## Application for Works Approval

<b>Works Approval Number</b>	W6455/2020/1
<b>Applicant</b>	Element 25 Limited
<b>ACN</b>	119 711 929
<b>File Number</b>	DER2020/000384
<b>Premises</b>	Butcherbird Manganese Project Mining tenement M52/1074 MEEKATHARRA WA
<b>Date of Report</b>	14 December 2020
<b>Decision</b>	Works approval granted

**Figure 2: Location of groundwater bores BBGW00013 and BBRC00215**

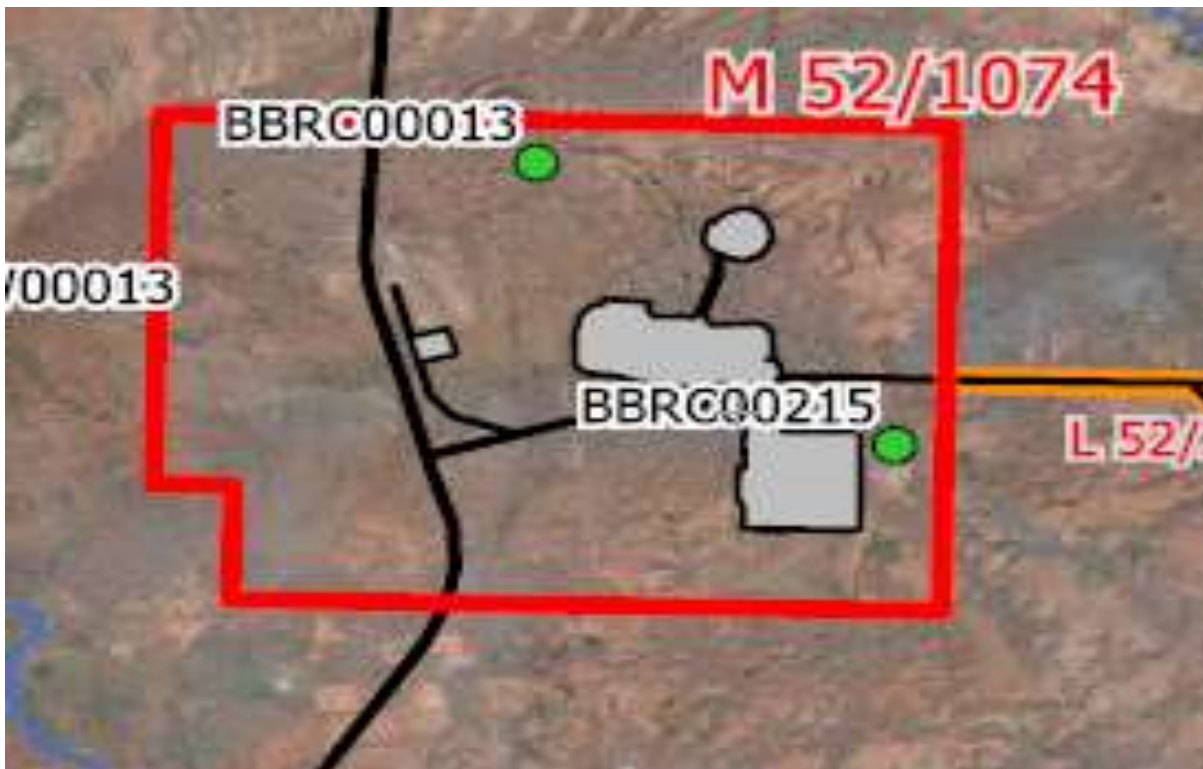
the water quality is marginal to brackish in salinity (2,760 mg/L at the TSF) with low level dissolved metals and major ions. The groundwater is suitable for livestock drinking in accordance the Livestock Drinking Water Guidelines within ANZECC 2000. The groundwater pH was found to be generally neutral to slightly alkaline with a range of 6.3 to 8.45. Results from sampling of the two groundwater bores located at the Premises (BBGW00013 and BBRC00215) are shown in Table 5 below. Groundwater bore BBRC00215 is located adjacent to the proposed TSF on the east side as shown in Figure 2 below.

The four test sites were just outside of the new proposed location for the TSF, however the results are expected to reflect the permeability at the new location following an assessment of an independent landform and soil mapping study (Schoknecht and Pathan, 2013). The study found the number of soils types within the Jamindie System for this area is limited and were found to be locally common and widespread. This type of underlying geology is likely to hinder seepage rate to groundwater.

- Prior to commissioning of the TSF, baseline groundwater sampling of the newly constructed groundwater monitoring bores is required;
- Applicant to provide a construction report within 60 days following completion of the TSF groundwater monitoring bores;
- Applicant to provide hydraulic specifications for the installed TSF clay liner; and
- Testing requirements of the in-situ clay liner to be installed at the base of the TSF.
